N5182A-05**S E R V I C E N O T E**

Supersedes:
None**N5182A MXG Vector Signal Generator**

Blank (Dark) LCD front panel may be caused by shorted LCD wires.

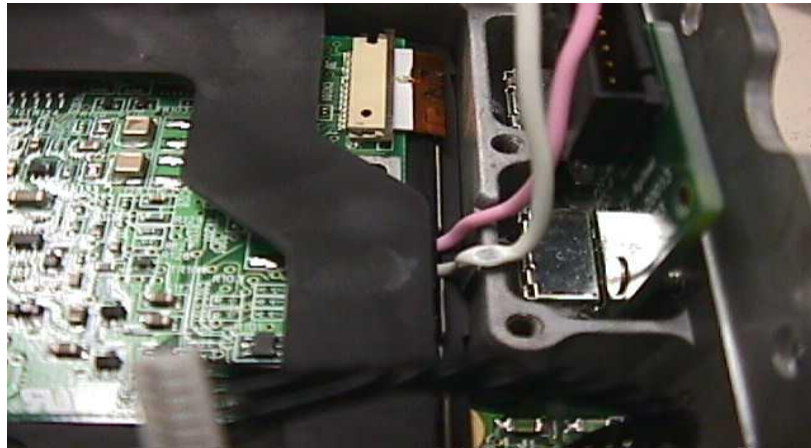
There has been a few random N5182A MXG Signal Generators discovered in the field with pinched Liquid Crystal Display (LCD) power leads. Though this is not a safety concern, the pinched LCD leads may overtime, become shorted resulting in a dark LCD display.

A N5182A MXG Signal Generator that appears to be operating correctly; unit turns-on, fans are functioning and the green power-on switch LED is visible but the front panel LCD screen is dark, may be the result of shorted power leads.

See example images below:

It is suggested that at the time of contact, the LCD leads be inspected for the possibility that the LCD leads are pinched. The LCD leads should move freely as they pass between the sub-panel sheet metal and the front panel casting. When in doubt, remove the front panel sub-panel in accordance with the MXG Service Guide. If the leads are found pinched, but no short has occurred. Reposition the affected lead(s) and if deemed necessary, apply insulating tape to the affected area. Re-assemble the front panel according to the MXG Service Guide ensuring the leads are no longer pinched.

When troubleshooting a MXG with a dark LCD, inspect for the pinched power leads as a possible cause of the dark display. If the leads are found pinched resulting in a physical short, replace the LCD assembly (P/N: N5180-60024) in accordance with the MXG Service Guide.

Additionally, it is recommended when LCD leads are uncovered as being shorted, the front panel Key Pad (P/N: N5180-60021) should also be replaced. While there is no direct empirical proof that the RPG on the Key Pad assembly has been damaged, a connection between shorted LCD lead(s) and the possibility of latent future RPG failures has been made, leading to a proactive desire to replace both assemblies.
